## ADDENDUM TO THE CONTRACT

### JNU SREF Site Infrastructure

Contract No. E12-280

**ADDENDUM NO.:** ONE

COVER SHEET INDEX  
 FILE NAME: JUV  
 AUTHOR: TJA  
 REVISIONS: 1  
 06/28/2012  
 CHECKED: BRH  
 JUNEAU CONTRACT # JNU E12-280  
 FAA AIP # 3-02-0133-051-2011

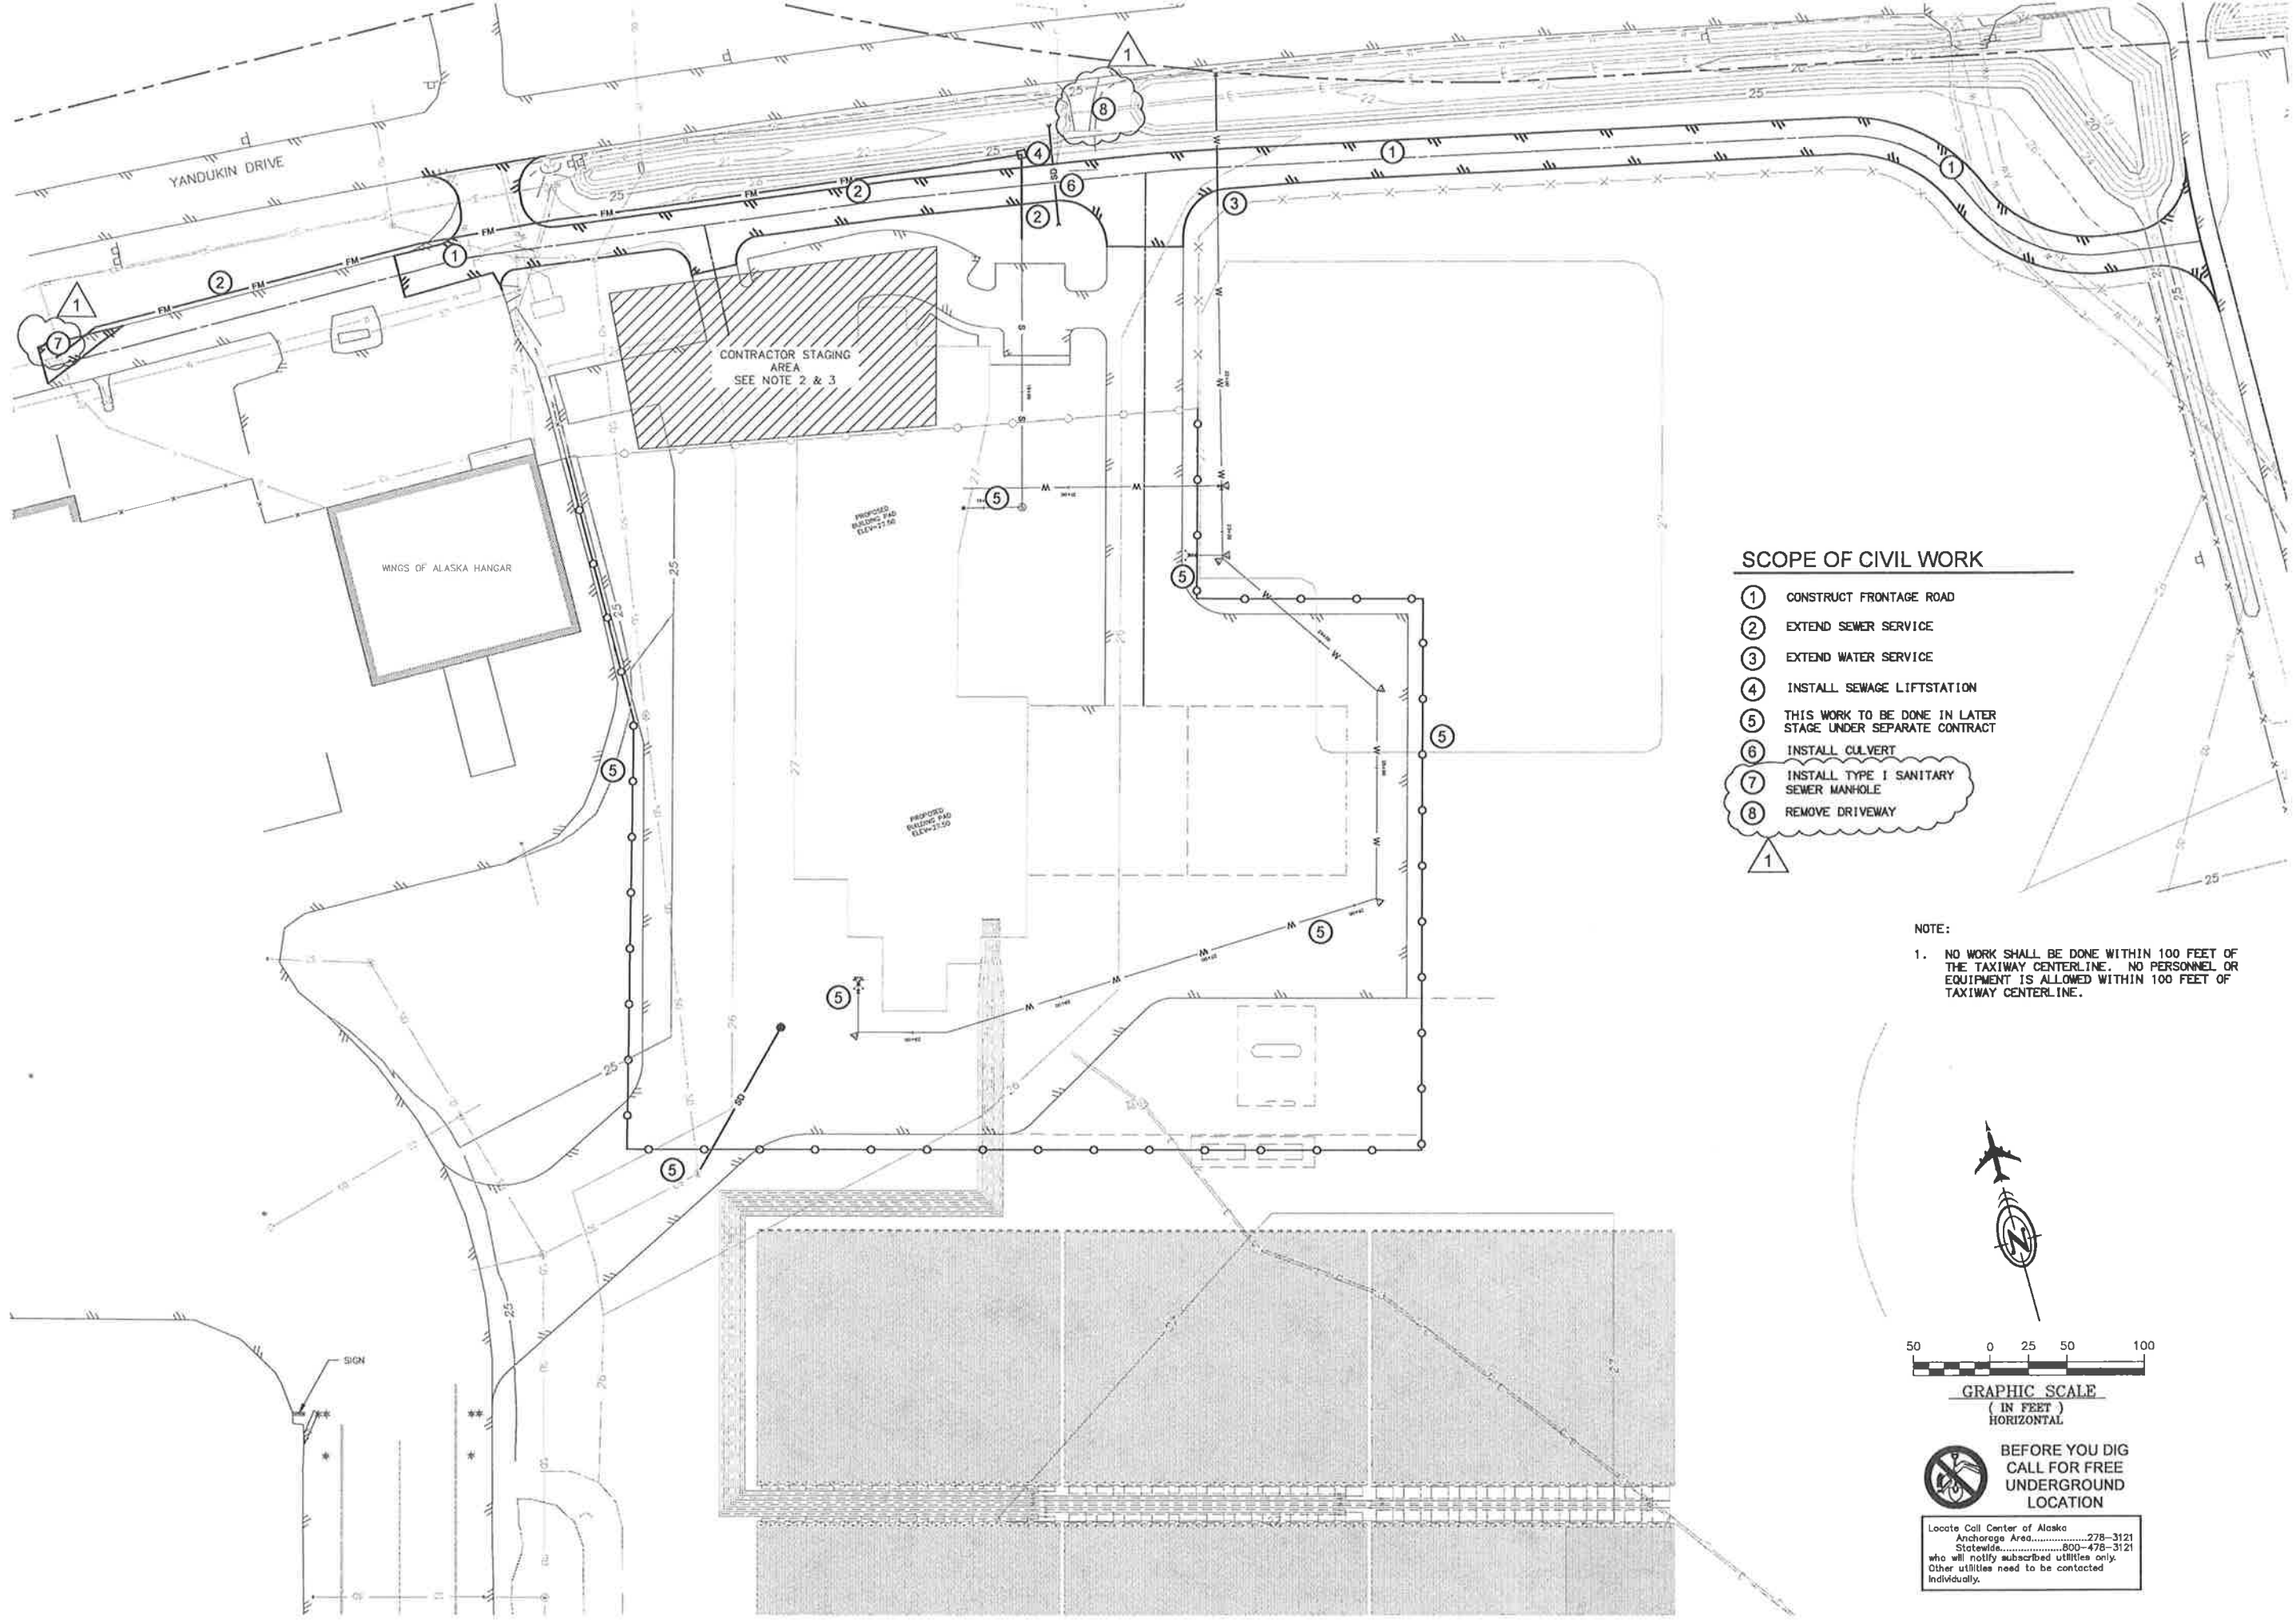
- Item No. 1: Drawing C-001, titled “Cover Sheet Index”, **replace** with the attached sheet: C-001, titled “Cover Sheet Index” Addendum 1.  
Principal Changes:  
➤ Added to Civil Notes:  
    CBJ Standard Detail 119A Junction Box Type 1 and Type 1A

**CIVIL PROJECT LAYOUT PLAN**  
 FILE NAME: J:\Projects\080021\080021\080021-01\080021-01.dwg  
 CHECKED: BRH  
 AUTHOR: TJA  
 JUNEAU CONTRACT # JNU E12-280  
 REVISIONS: 1  
 FAA AIP #3-02-0133-051-2011  
 06/28/2012

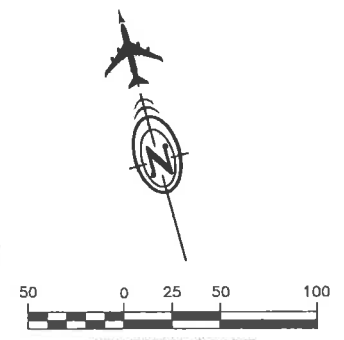
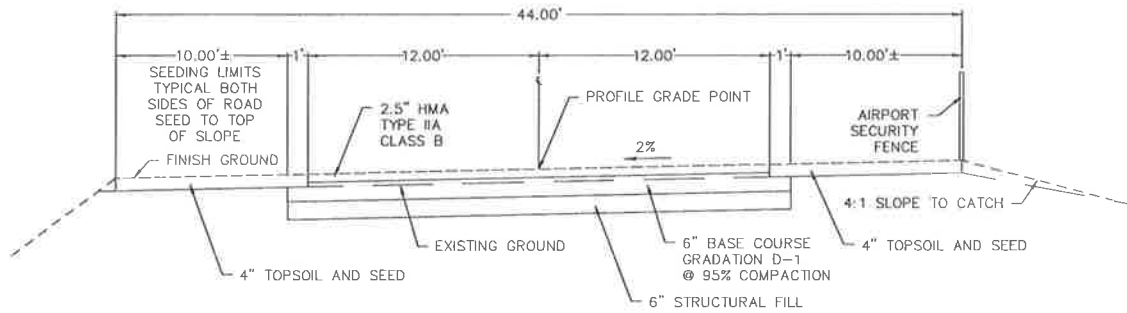
- Item No. 2: Drawing C-002, titled “Civil Project Layout Plan”, **replace** with the attached sheet: C-002, titled “Civil Project Layout Plan” Addendum 1  
Principal Changes:  
➤ Added Scope Item 7 Install Type I Sanitary Sewer Manhole  
➤ Added Scope Item 8 Remove Driveway

**4 DUPLEX PUMP LIFT STATION DETAIL**  
 NTS  
 C-003

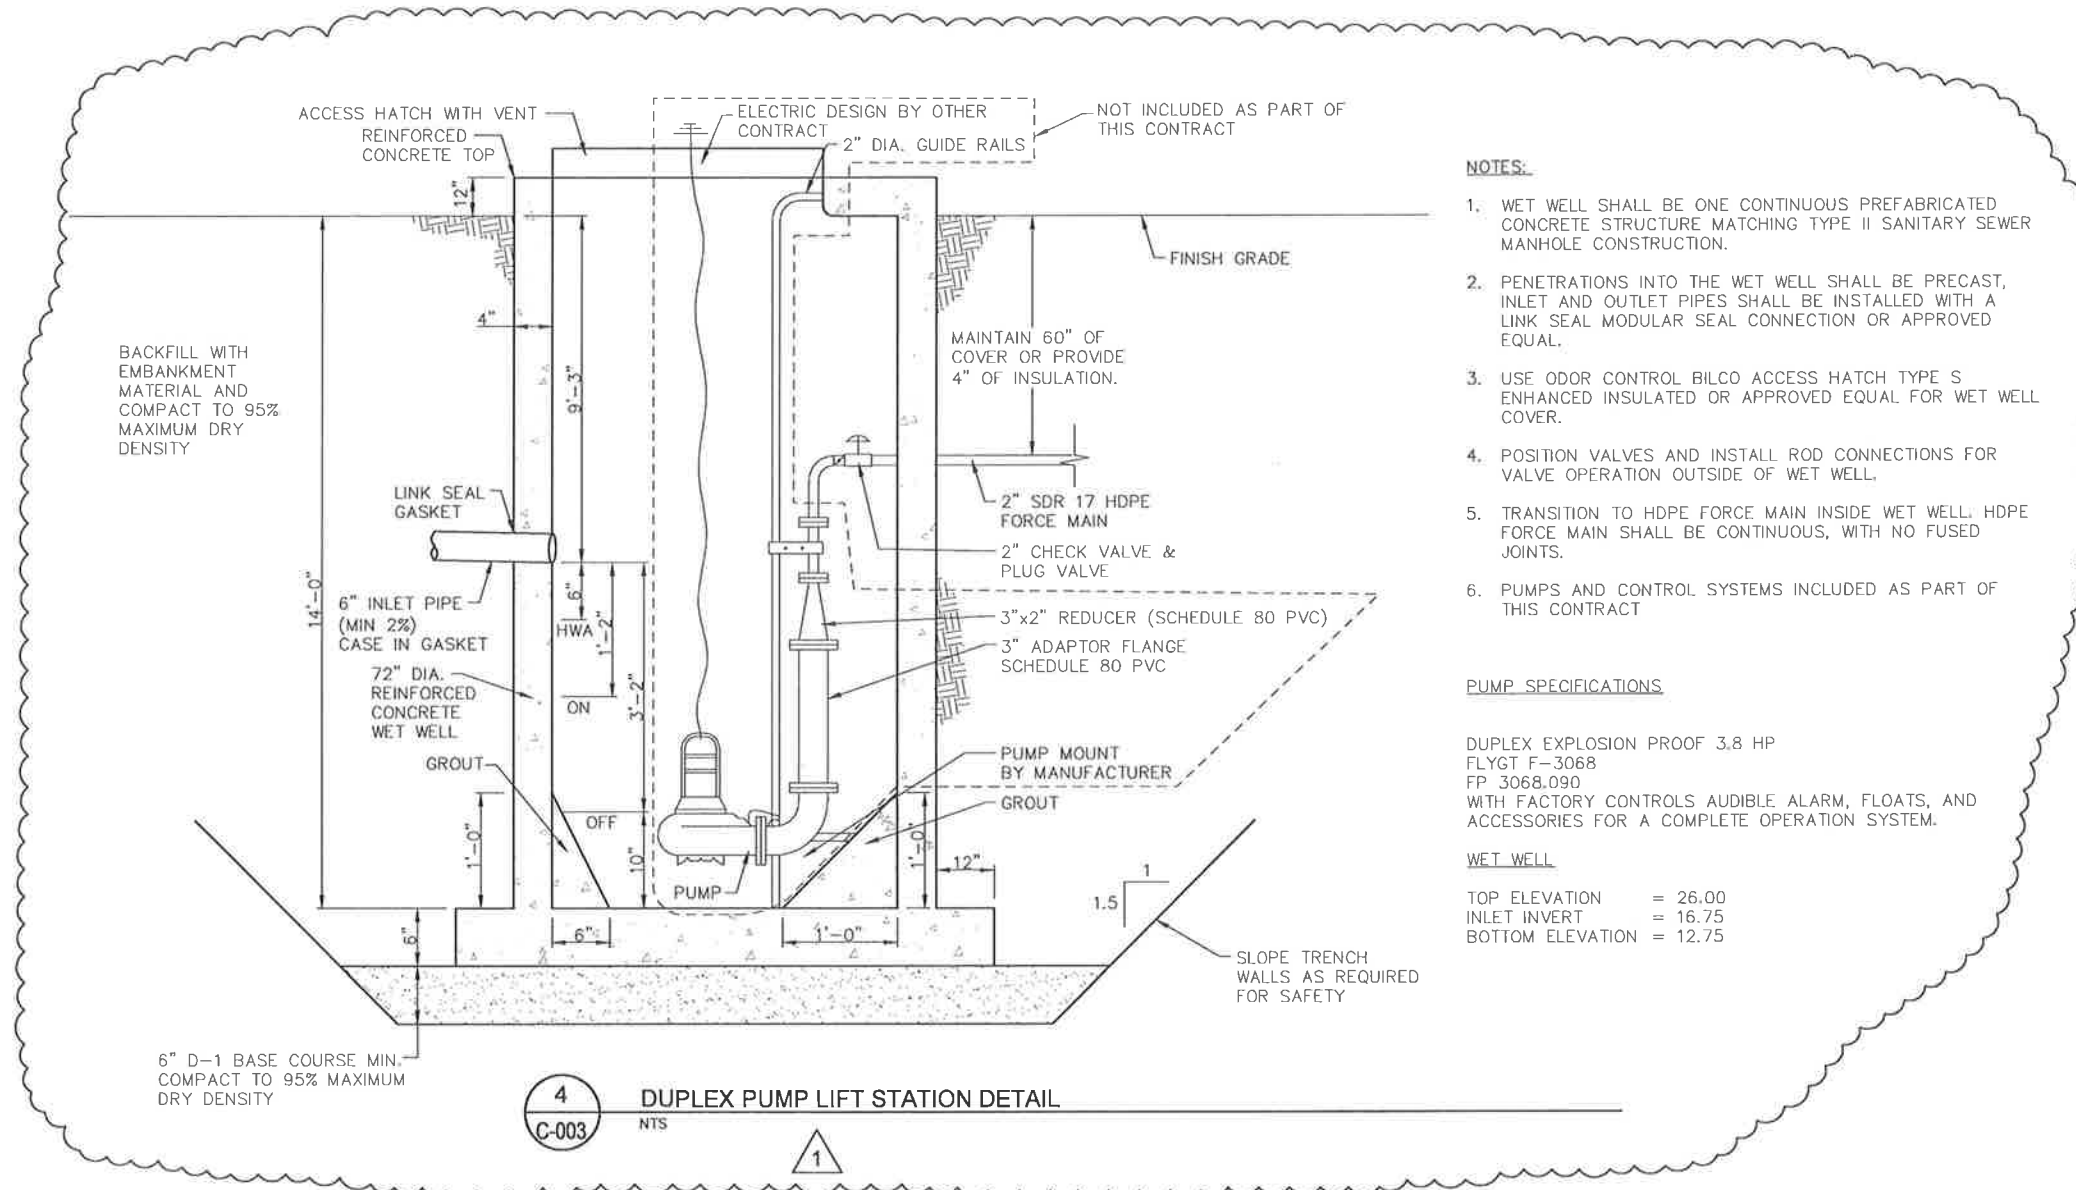
- Item No. 3: Drawing C-003, titled “Typical Sections & Details”, **replace** with the attached sheet : C-003, titled “Typical Sections & Details” Addendum 1  
Principal Changes:  
➤ Added Detail 4 Lift Station Detail

- NOTES:**
1. WET WELL SHALL BE ONE CONTINUOUS PREFABRICATED CONCRETE STRUCTURE MATCHING TYPE II SANITARY SEWER MANHOLE CONSTRUCTION.
  2. PENETRATIONS INTO THE WET WELL SHALL BE PRECAST, INLET AND OUTLET PIPES SHALL BE INSTALLED WITH A LINK SEAL MODULAR SEAL CONNECTION OR APPROVED EQUAL.
  3. USE ODOR CONTROL BILCO ACCESS HATCH TYPE S ENHANCED INSULATED OR APPROVED EQUAL FOR WET WELL COVER.
  4. POSITION VALVES AND INSTALL ROD CONNECTIONS FOR VALVE OPERATION OUTSIDE OF WET WELL.
  5. TRANSITION TO HDPE FORCE MAIN INSIDE WET WELL. HDPE FORCE MAIN SHALL BE CONTINUOUS, WITH NO FUSED JOINTS.
  6. PUMPS AND CONTROL SYSTEMS INCLUDED AS PART OF THIS CONTRACT
